# UNITED STATES PATENT AND TRADEMARK OFFICE

APPLICATION NO.	FILING DATE	FIRST NAMED INVENTOR	ATTORNEY DOCKET NO.	CONFIRMATION NO.
10/804,401	03/18/2004	Robert W. Ratte	5844	7377
44341	7590	07/02/2007		
JACOBSON & JOHNSON ONE WEST WATER STREET, SUITE 285 ST. PAUL, MN 55107			EXAMINER ALEJANDRO, RAYMOND	
			ART UNIT 1745	PAPER NUMBER
			MAIL DATE 07/02/2007	DELIVERY MODE PAPER

**Office Action Summary**

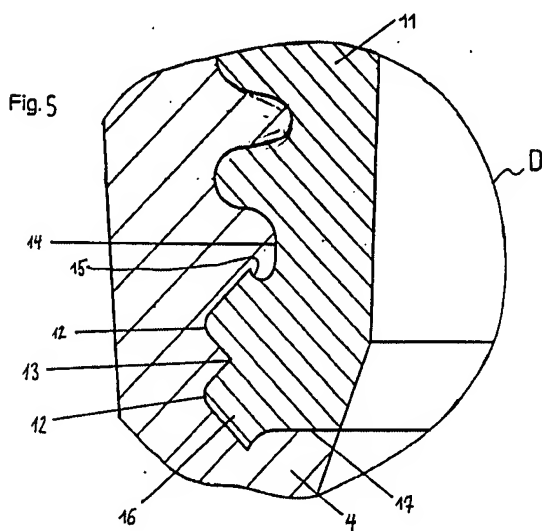
The EP'268 discloses terminal for batteries wherein the terminal includes continuous grooves (the acid rings) which can be inserted into a battery case (ABSTRACT/COL 1, lines 30-55). Specifically, **Figure 5** depicts grooves on the battery terminal having an acute angle, or angle less than 90°, or V-shaped groove (See reference numerals 42-43 below). The groove has at least two lips (see reference numerals 42).

In view of the above, it would have been obvious to a person possessing a level of ordinary skill in the pertinent art at the time the invention was made to shape the acid rings on the battery terminal of the AAPA to have either an acute angle, or angle less than 90°, or V-shaped groove as taught by the EP'268 as the EP'268 teaches that such groove (angle) configuration facilitates sealing between the terminal and the battery accumulator. Thus, the specific shape of the grooves improves the sealing characteristics of the battery. Furthermore, this is consistent with the teachings of the AAPA that battery terminals are shaped to prevent the container from shrinking away from the terminal and upsetting the interface between the battery part and the container which could cause leakage of electrolyte. Generally, acid rings provide lateral engagement between the acid rings and the container (*Applicant's specification pages 2-7*) and are shaped to form a lateral restraint between the battery container and the terminal (*Applicant's specification pages 2-7*). Furthermore, it is noted changes in shape is a matter of choice which a person of ordinary skill in the art would have found obvious absent persuasive evidence that the particular configuration of the claimed acid rings (groove) is significant. *In re Dailey*, 149 USPQ 47. It is also noted that aesthetic design changes having no mechanical function cannot be relied upon to patentably distinguish the claimed invention from the prior art. *In re Seid*, 73 USPQ 431. (See MPEP 2144.04 [R-1] Legal Precedent as Source of Supporting Rationale).

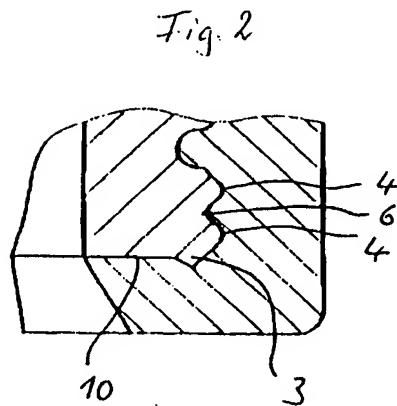
Specifically, **Figure 2** depicts grooves on the battery terminal having an acute angle; or angle less than 90°, or V-shaped groove (See reference numerals 4 and 6 below). The groove has at least two lips (see reference numerals 4).

In view of the above, it would have been obvious to a person possessing a level of ordinary skill in the pertinent art at the time the invention was made to shape the acid rings on the battery terminal of the AAPA to have either an acute angle, or angle less than 90°, or V-shaped groove as taught by the GE'956 as the GE'956 teaches that such groove (angle) configuration forms a seal and increase the sealing effect. Thus, it provides the advantage of improving sealing against the battery cover. Furthermore, this is consistent with the teachings of the AAPA that battery terminals are shaped to prevent the container from shrinking away from the terminal and upsetting the interface between the battery part and the container which could cause leakage of electrolyte. Generally, acid rings provide lateral engagement between the acid
